HOSHIZAKI AMERICA, INC.

SERVICE BULLETIN

SB17-0006

Subject: AM-50 Board 463046-01 subs to SP-5257

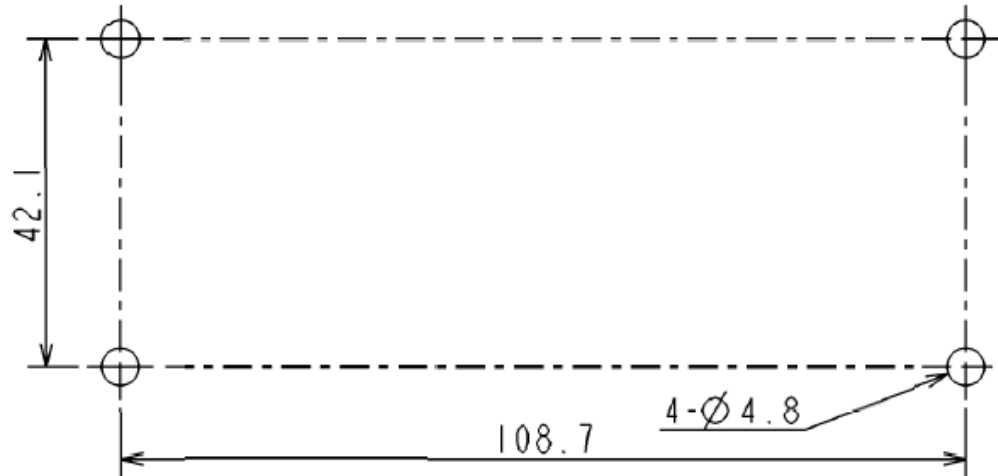
The original AM-50BAE board is no longer available. Therefore, service kit SP-5257 has been created to allow the use of the current control board.

This conversion will require modification to the existing control box and wiring and should only be done by a qualified service technician. The service kit includes a drilling template as well as new wiring label.

Example of instruction/drilling template and wiring label has been provided with this Service Bulletin. Note: The provided drilling template is not to scale.

1. REMOVE CONTROL BOX COVER
2. DISCONNECT WIRING TO CONTROL BOARD AND REMOVE CONTROL BOARD.
3. REMOVE SCREW HOLDING CAPACITOR.
4. REMOVE CONTROL BOX FROM ICE MACHINE.
5. LOCATE TEMPLATE ON OUTSIDE AND DRILL (4) Ø4.8 (.188) HOLES AND (2) Ø3.2 (.125) HOLES. DEBURR HOLES.
6. INSTALL NEW BOARD SUPPORTS AND CONTROL BOARD.
7. INSTALL TRANSFORMER USING T2 SCREWS IN Ø3.2 HOLES.
8. REINSTALL CAPACITOR.
9. REWIRE PER 3A9472-01 WIRING LABEL.
